RENESAS TECHNICAL UPDATE

Product Category	SOC		Document No.	TN-RE*-A0002A/E	Rev.	1.00
Title	Errata to RE01Group User's Manual:Hardware		Information Category	Technical Notification		
Applicable Product	RE01 Products with 256-Kbyte Flash Memory	Lot No.	Reference Document	RE01 Group User's Manual:Hardware Rev.1.00 (R01UH0894EJ0100)		
		All

This document describes corrections to the RE01 Group User's Manual: Hardware, Rev.1.00.

Figure 1.3 Energy harvesting startup mode with the VREF in use

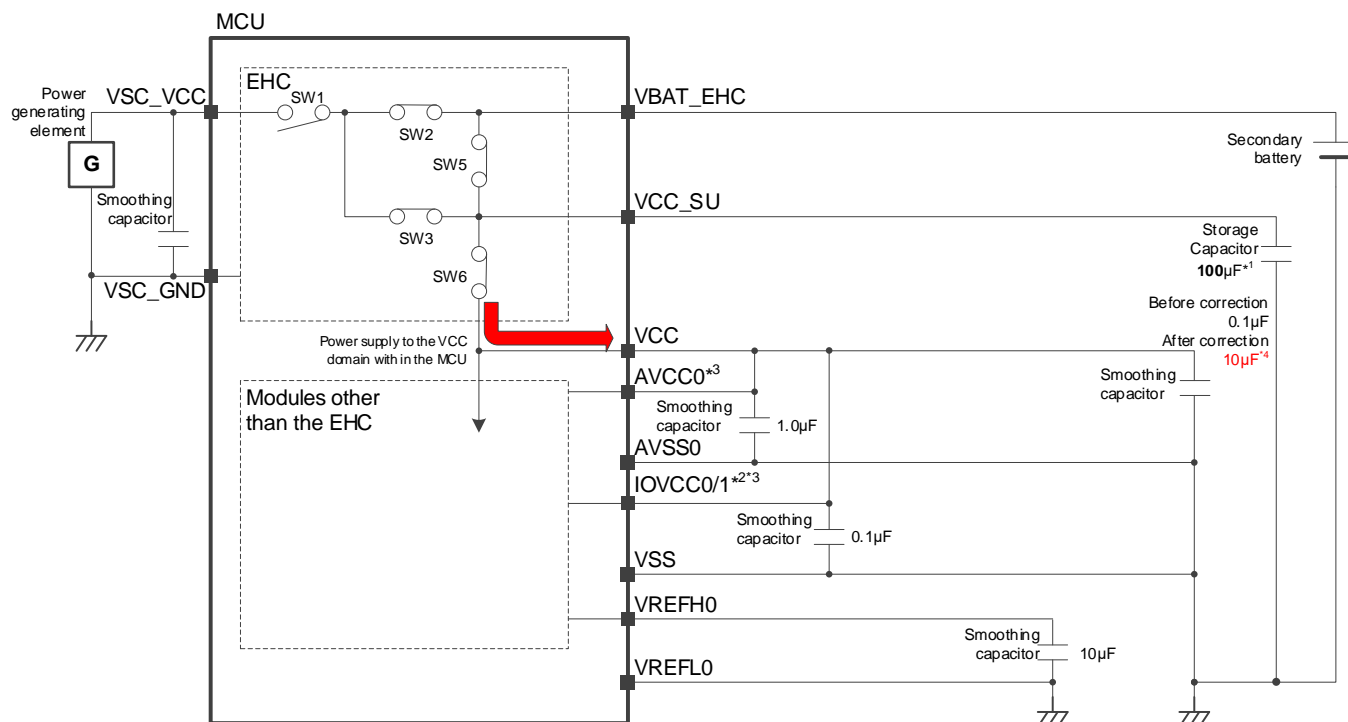
The capacitance of a smoothing capacitor will be corrected in Figure 1.3 Energy harvesting startup mode with the VREF in use and Figure 1.4 Energy harvesting startup mode with AVCC0 as the reference voltage

Note4: The capacitance should be at least 1/10 that of the storage capacitor connected to the VCC_SU pin.
